H TECHNICAL BULLETIN

Air Control System Enhancement

SUBJECT: Part No. R-013462 and Service Kit
No. R-013282

LIT NO: TB-H761

FIGURE 1

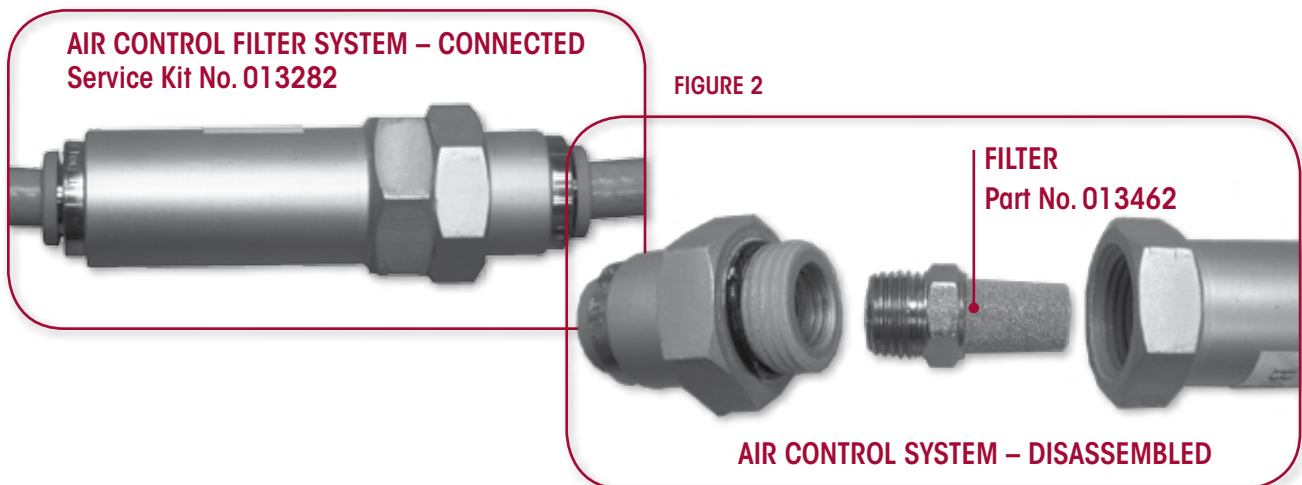
In addition, a NEW Air Control Filter System Service Kit (Number R-013282), see Figure 1, is available in the aftermarket to install on existing compatible Hendrickson auxiliary axle air control systems, refer to Table 1 on page 2. Likewise the filter (Part Number R-013462) itself, see Figure 2, is also available in the aftermarket for component replacement.
